PRELIMINARY OVERALL AREA  
DEVELOPMENT PLAN

MAINLAND OAKS SUBDIVISION

RE: Mainland Oaks Subdivision POADP #396

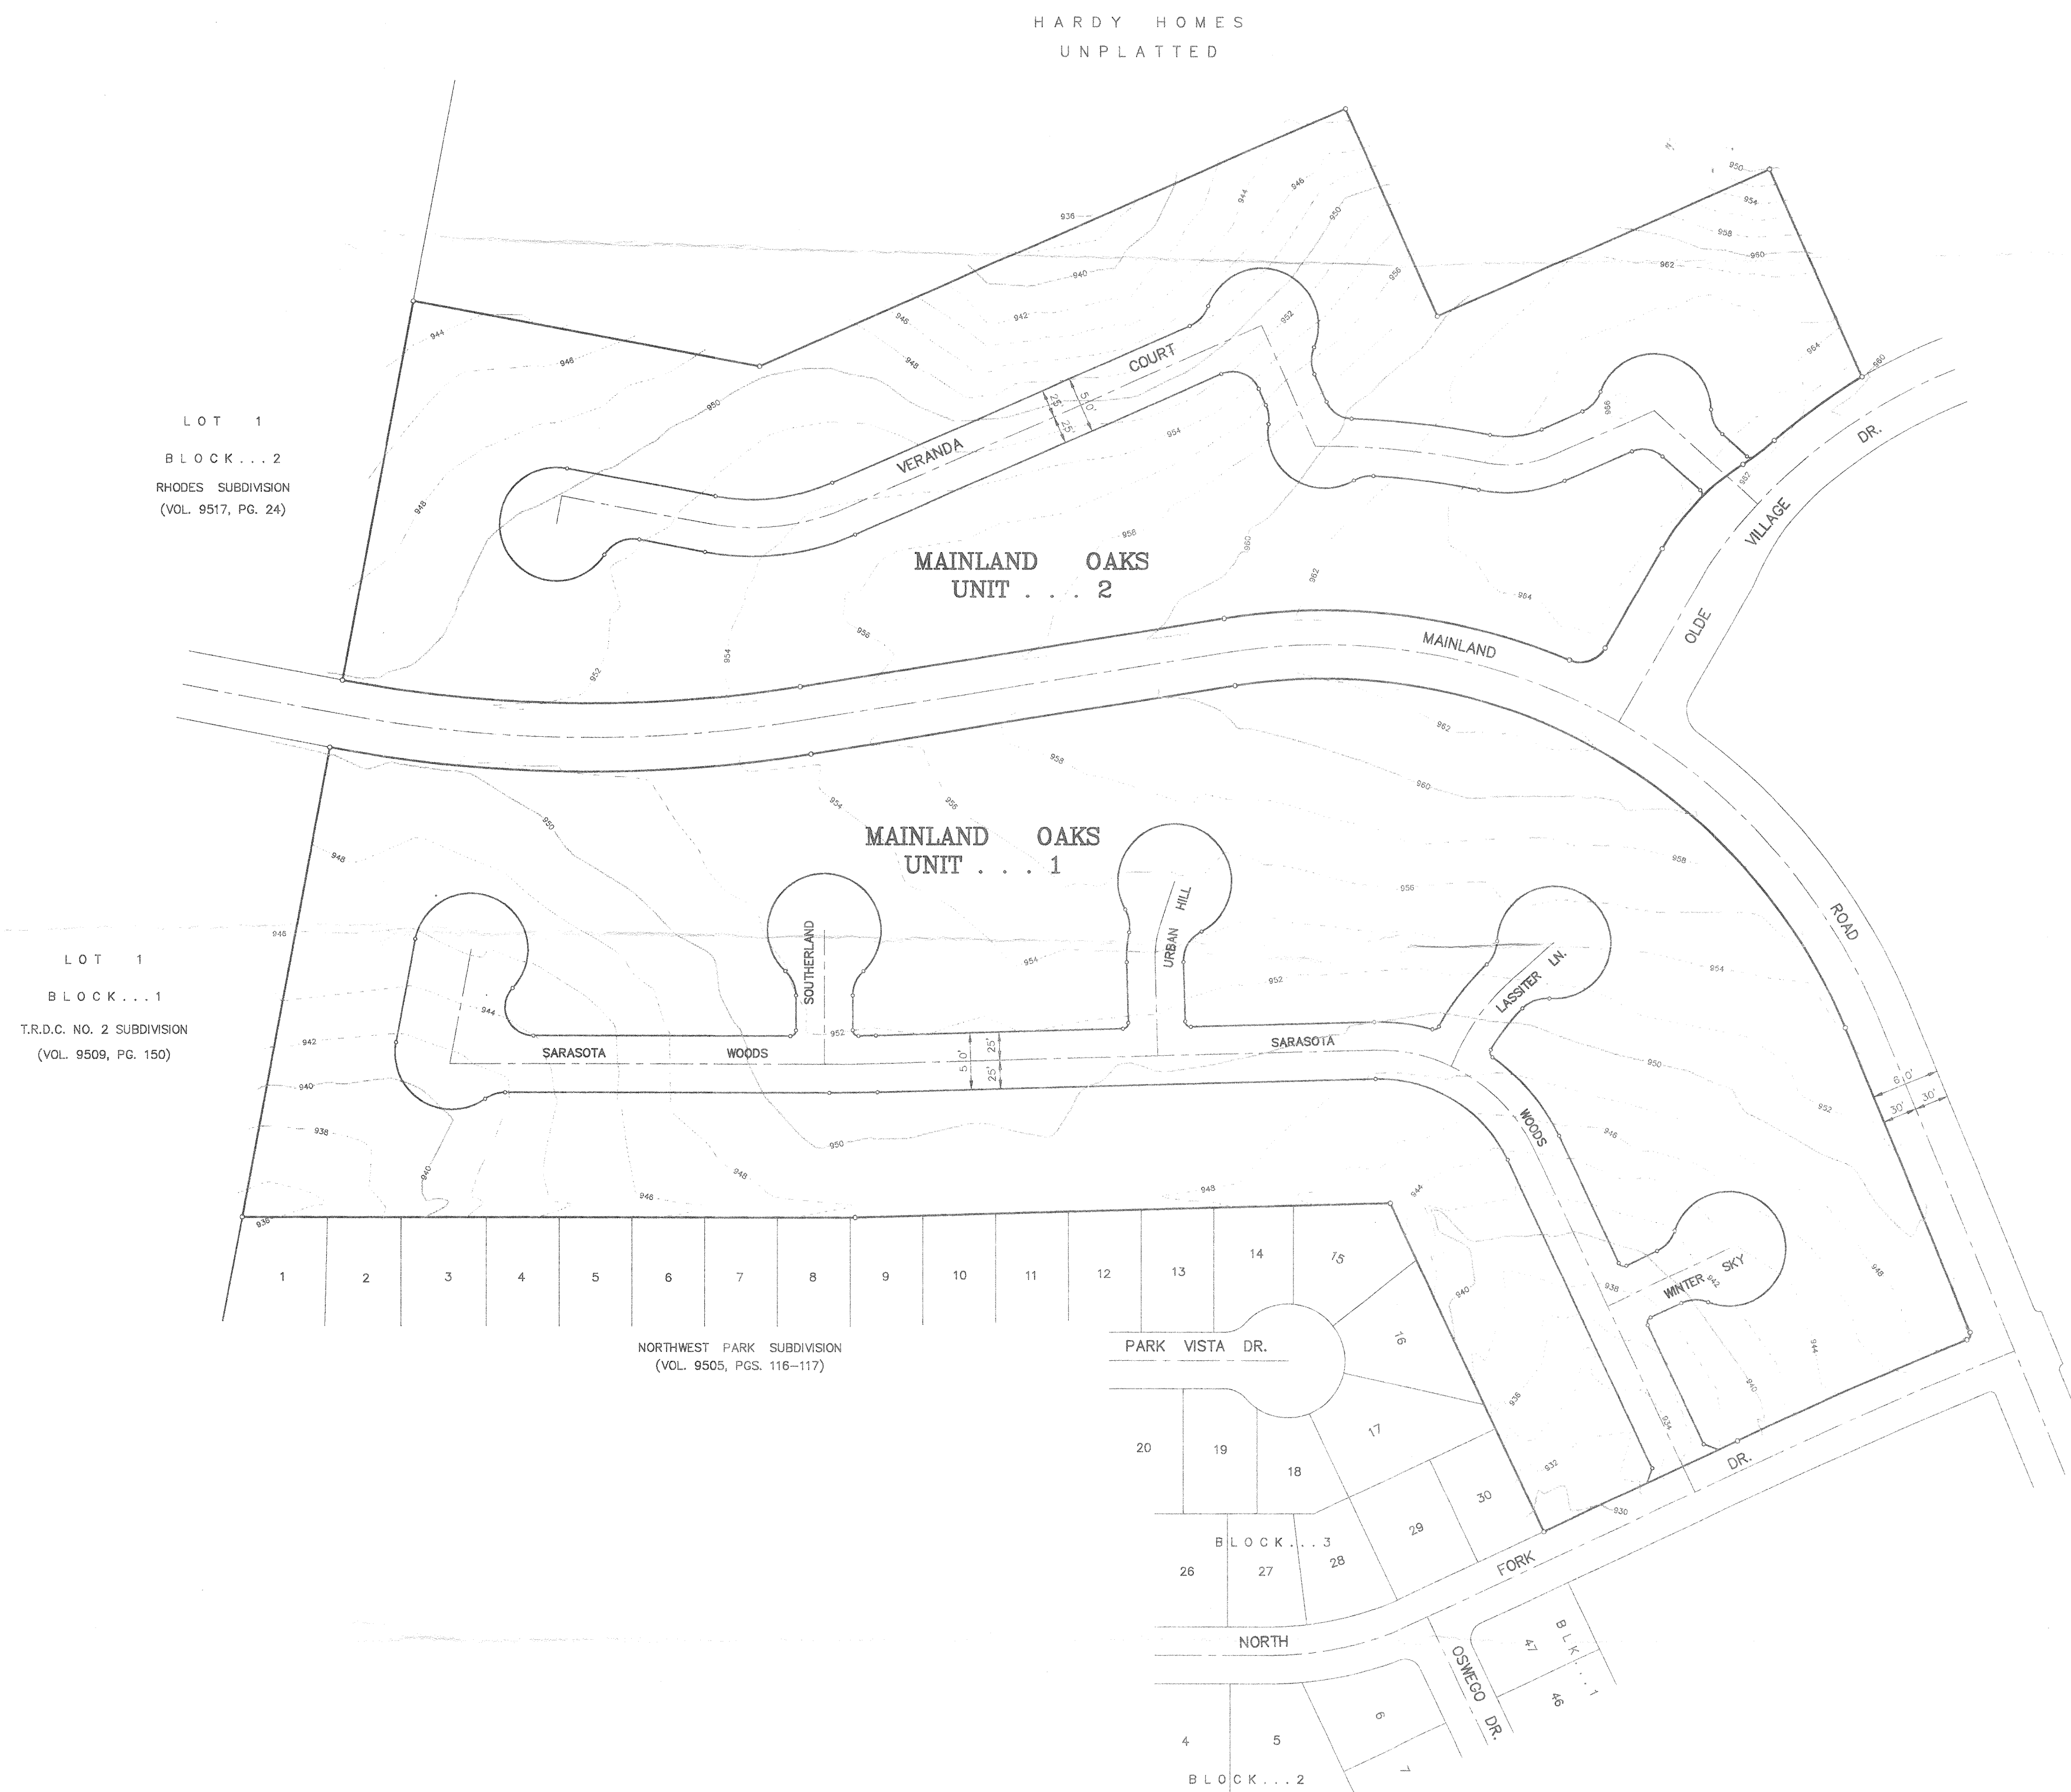
The City Staff Development Review Committee has reviewed your Mainland Oaks Subdivision Preliminary Overall Area Development Plan #396. Please find enclosed a signed copy for your files. You may now submit individual subdivision plat units at your convenience. Although your plan was accepted, a non-access easement will be required along the rear and sides of lots adjacent to Mainland Road at the time of plat submittal.
